**Town of Kittery
Planning Board Meeting
February 13, 2020**

ITEM 1 – 76 Dennett Road – Sidewalk/Street/Landscape Design Discussion

Re: Landscape Design Review
Response to Ironwood Design Group Review Comments
Proposed Mixed-Use Development at 76 Dennett Road
Tax Maps Lots 6-15B, 6-16A, 13-4, Kittery, Maine

**RE: Town of Kittery, Planning Board Services
Mixed-Use Development Proposal – 76 Dennett Road Lots 6-15B, 6-16A, 13-4
Final Review Comments - January 23, 2020 Submittal
CMA #591.125**

APPLICANT	AZTEC, LLC 62 PORTLAND ROAD, SUITE 25 KENNEBUNK, ME 04043
PROJECT	PROPOSED MIXED-USE RESIDENTIAL DEVELOPMENT PROJECT TAX MAP LOTS 6-15B, 6-16A & 13-4 76 DENNETT ROAD, KITTERY, ME 03904
PROJECT NO.	569200
SHEET	13 OF 27

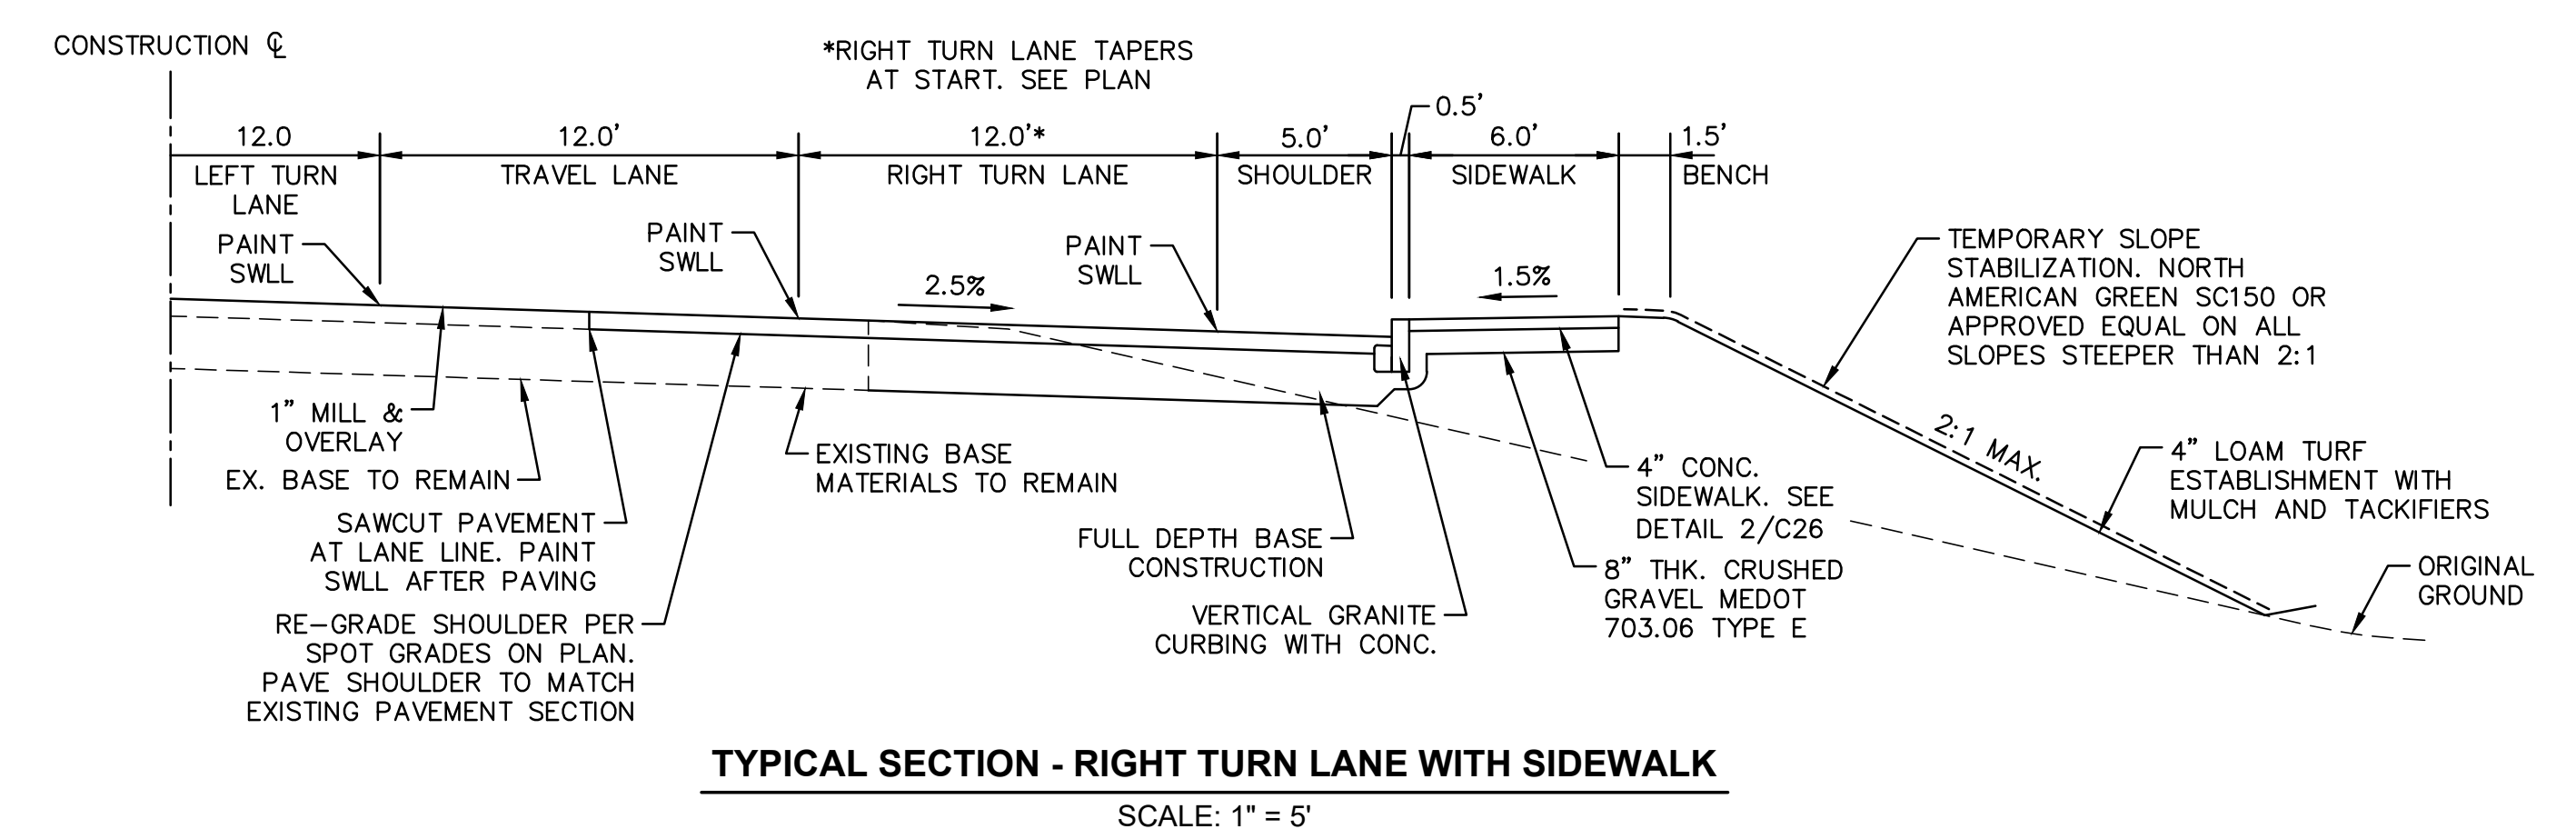
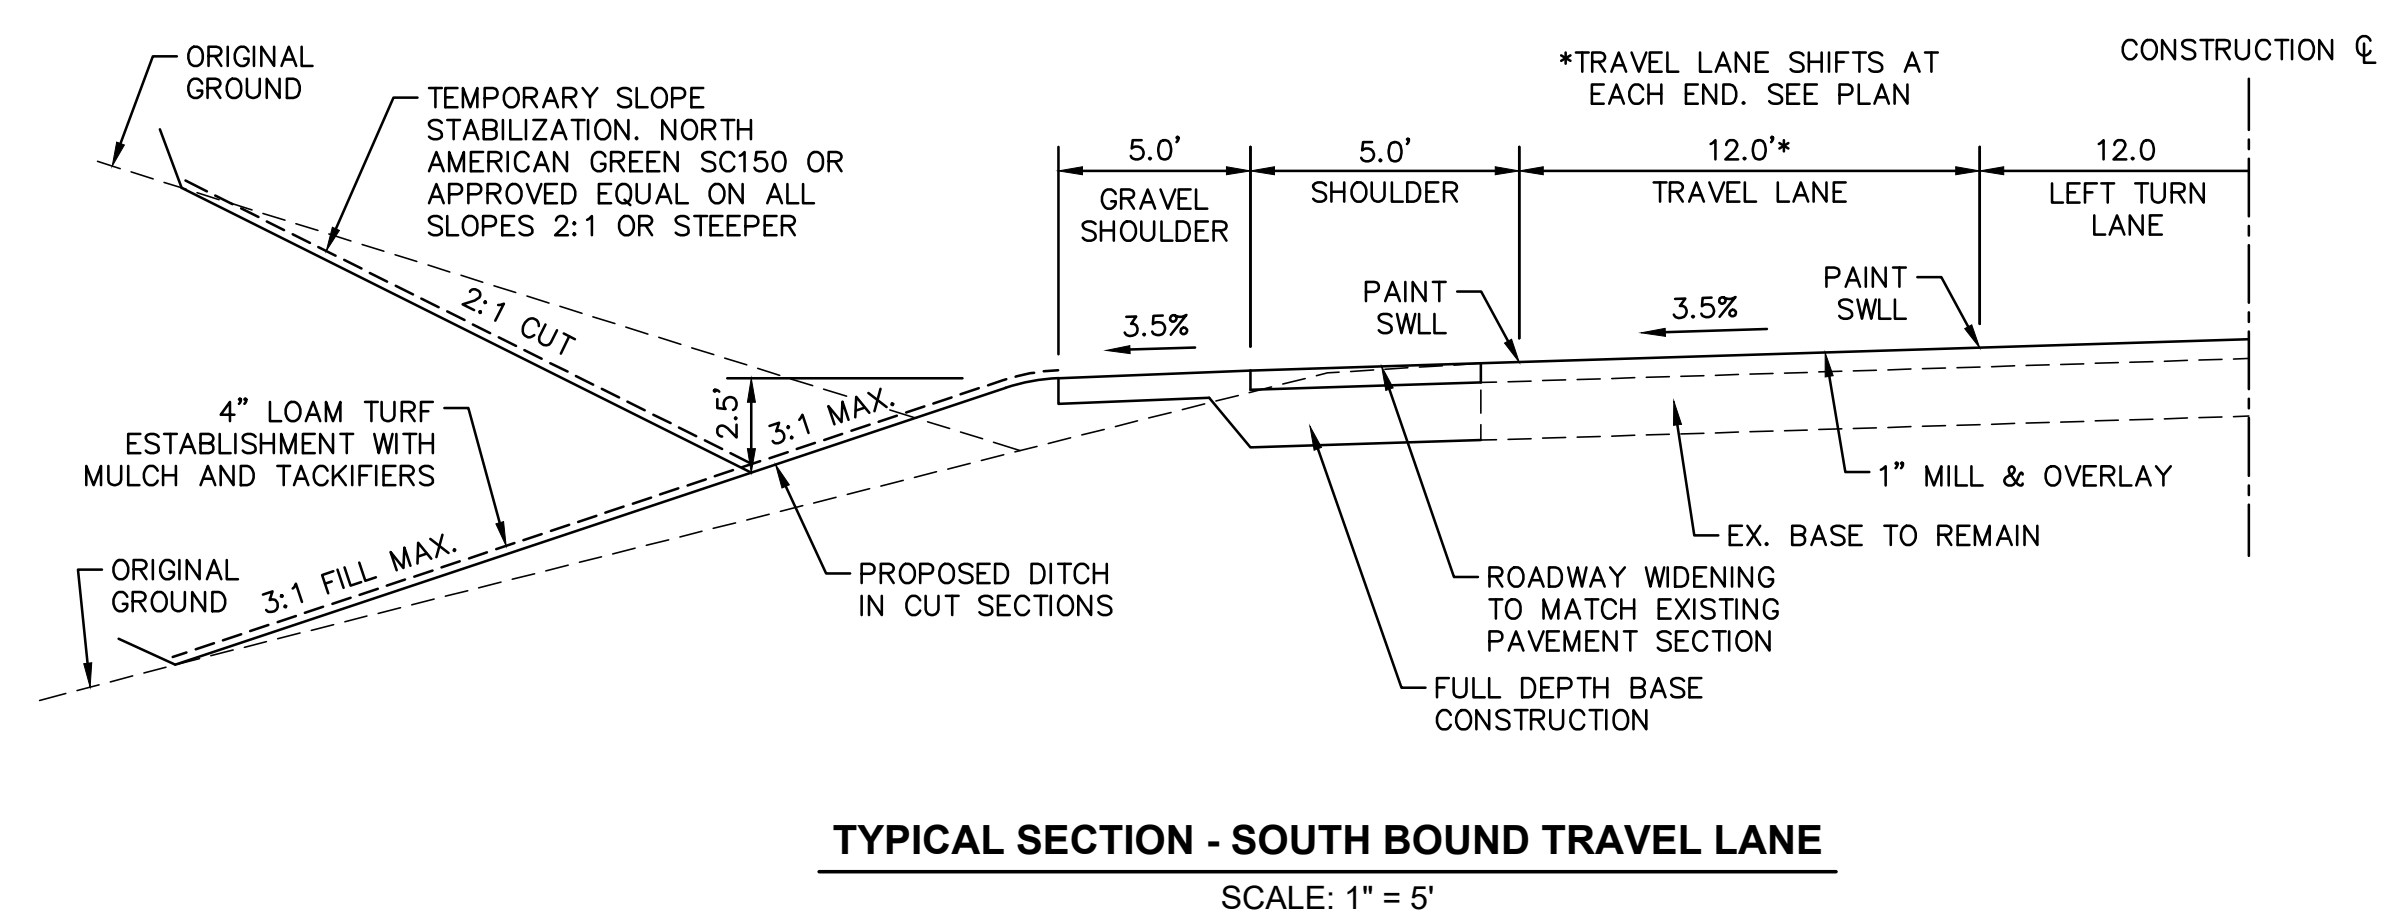
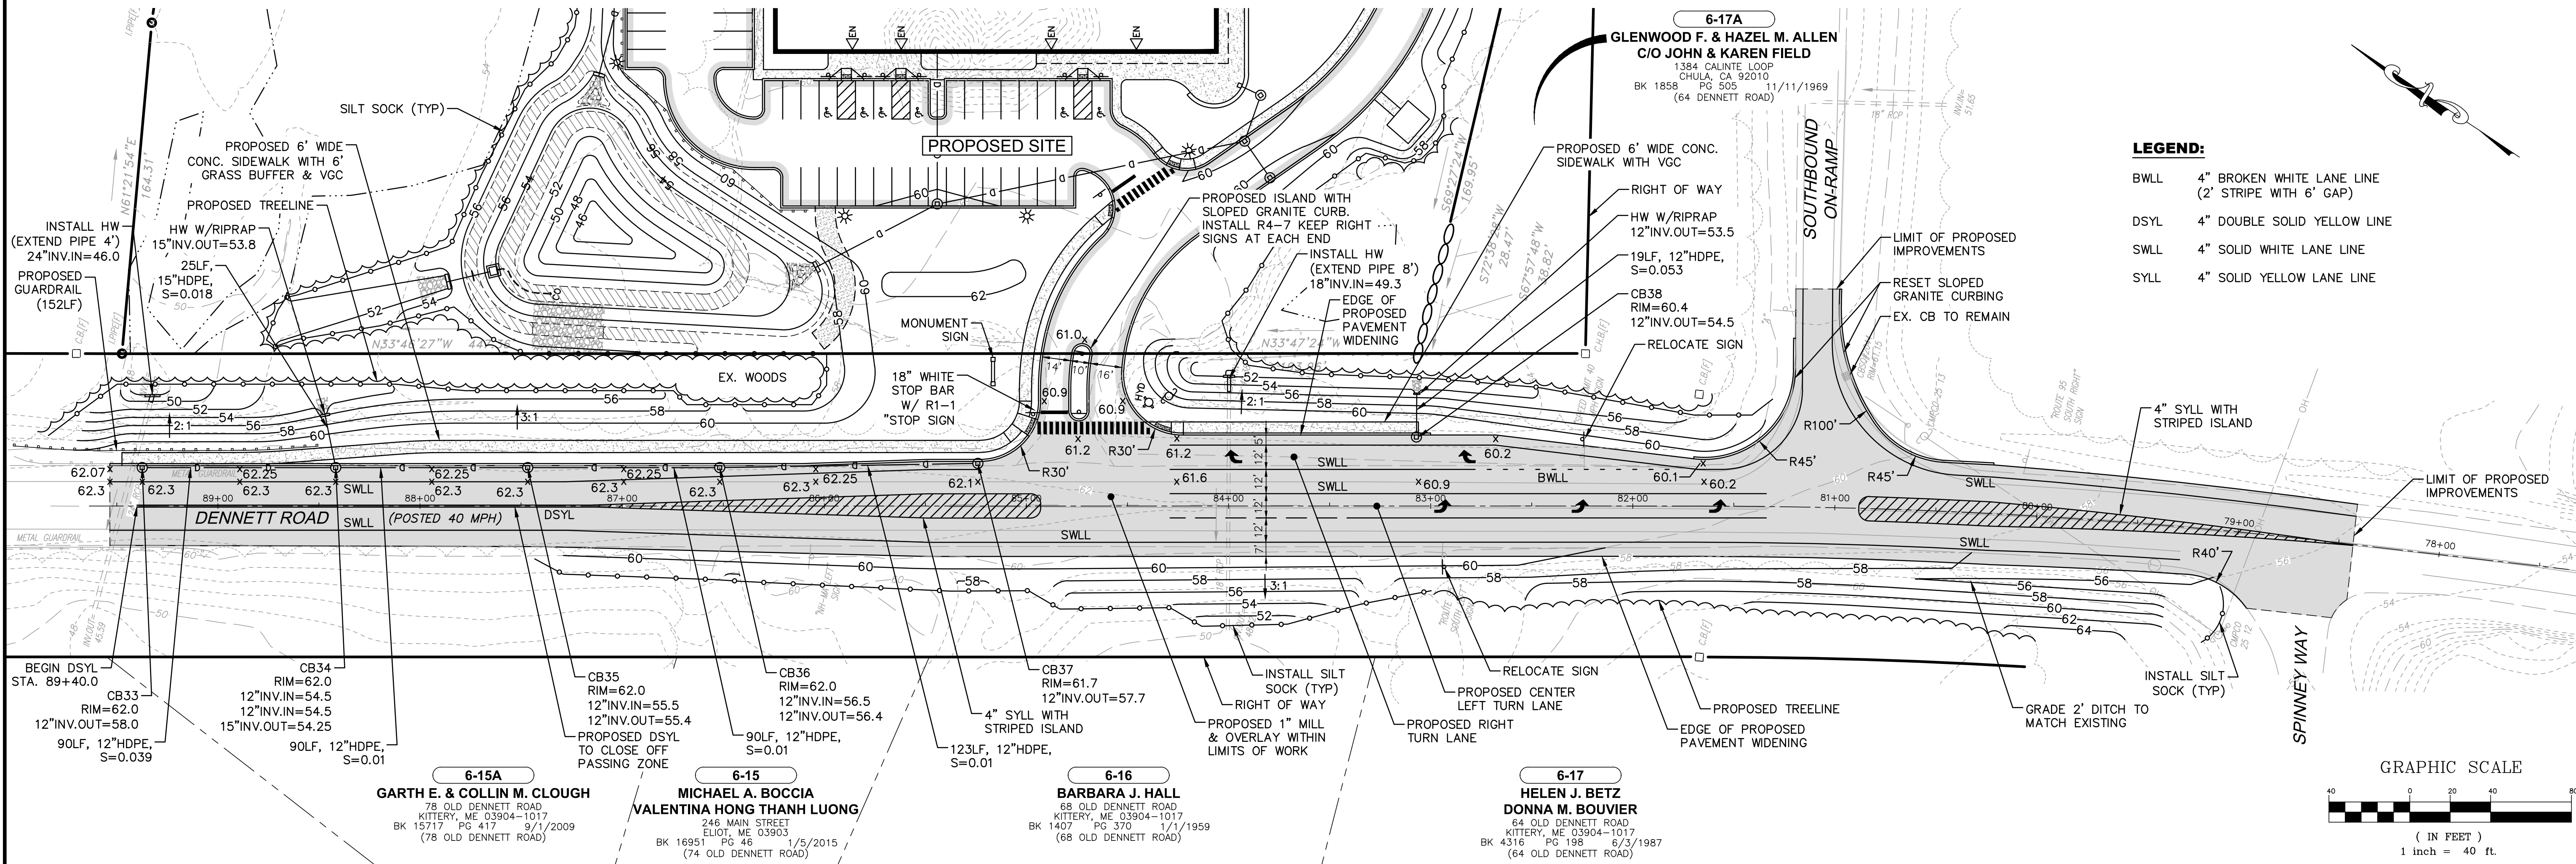
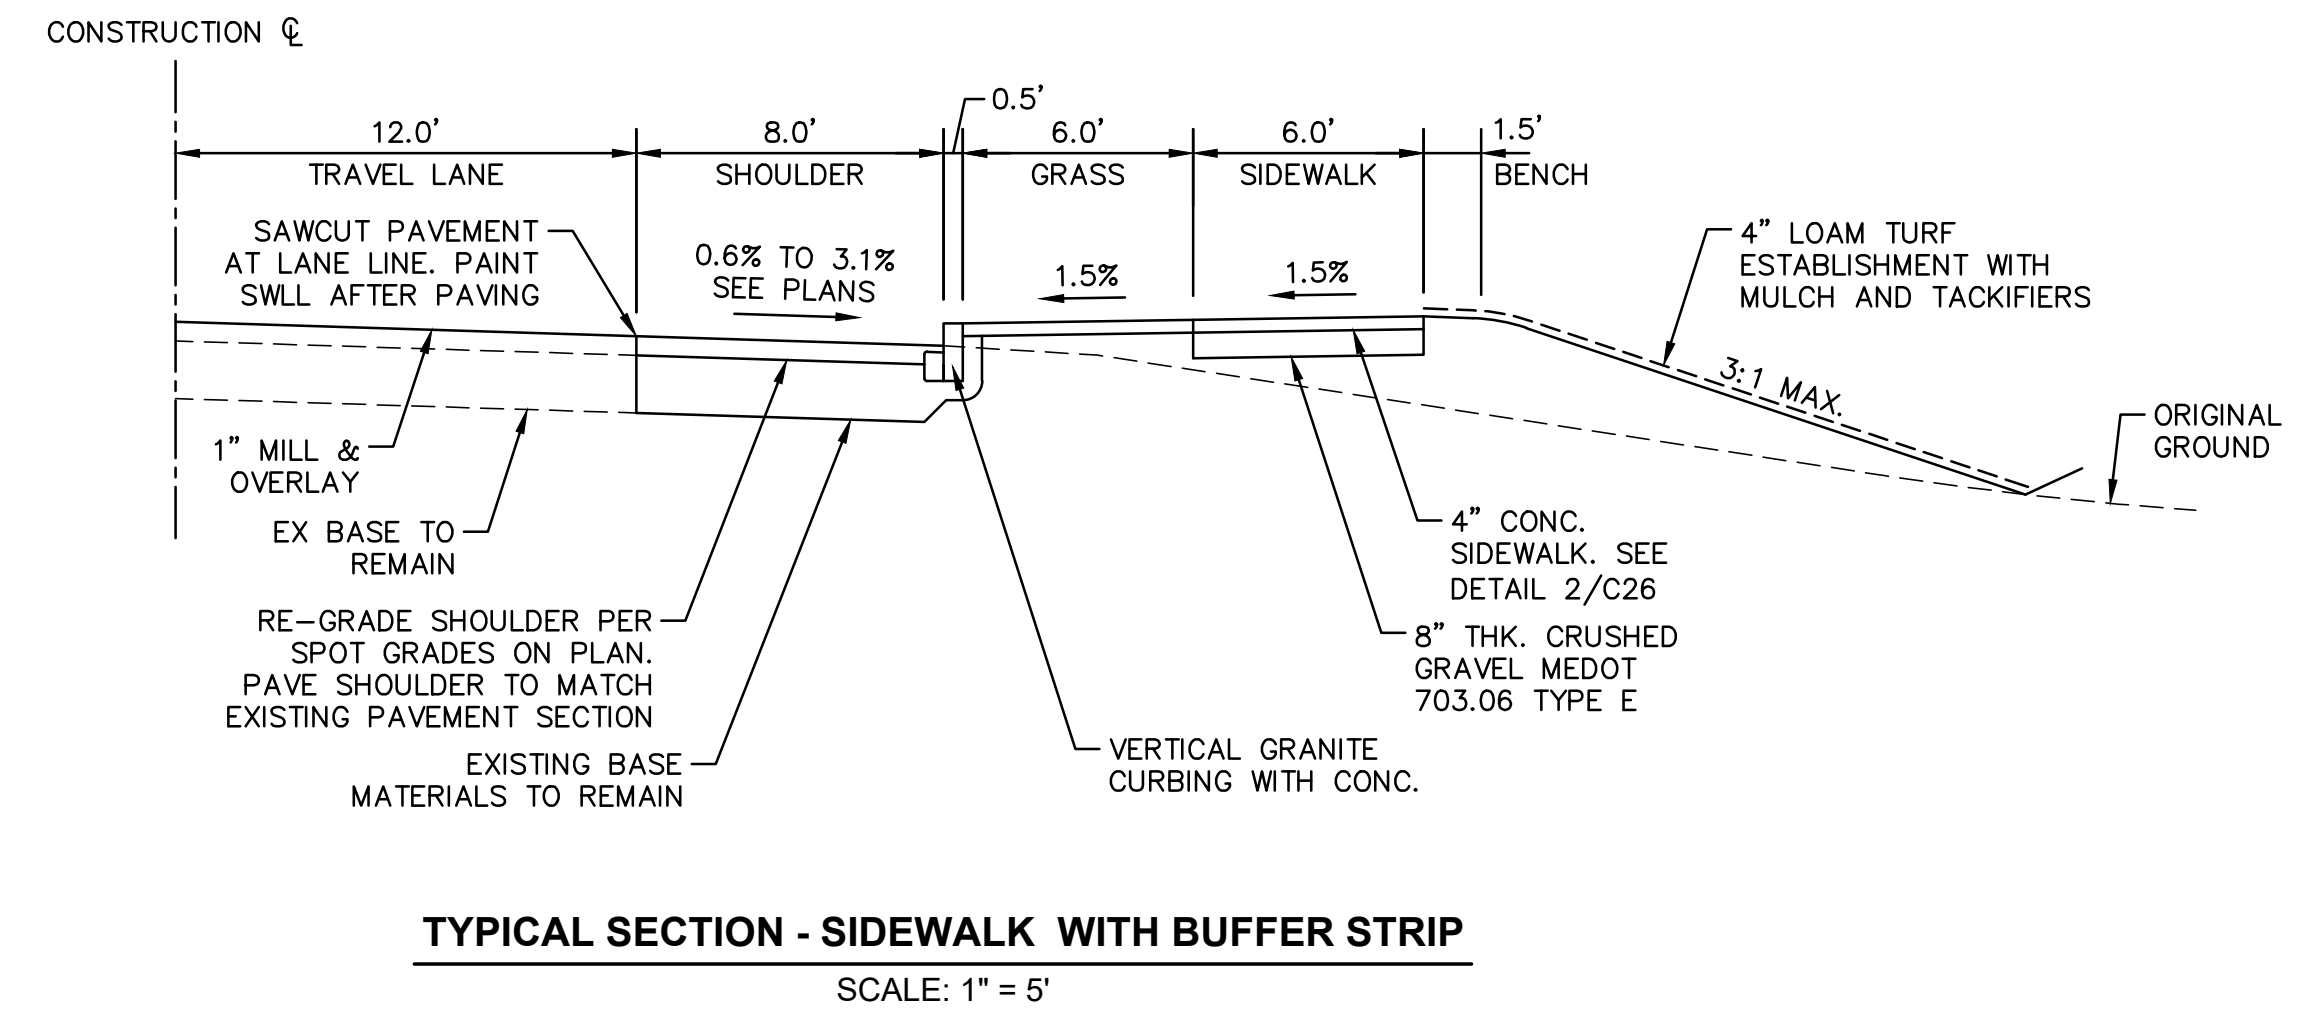
The sidewalk detail drawings don't quite align with the plan (regarding which sidewalk design segment includes the guard rail and certain shoulder widths). The plan shows there will be vegetation removal and grading involved with the sidewalk installation.

On January 9, 2020, we provided you a letter with review comments on the project's Traffic Movement Permit, including a traffic study. In addition, we commented via email dated January 16, 2020 regarding issues associated with providing sidewalks. The final revised drawing C13 (Dennett Road Improvement Plan):

- Satisfactorily incorporates our recommendations for configuration of the turning lanes and their expected functioning with respect to the traffic study, and
- Incorporates a supportable and reasonably designed and integrated sidewalk along the lot's frontage on Dennett Road.
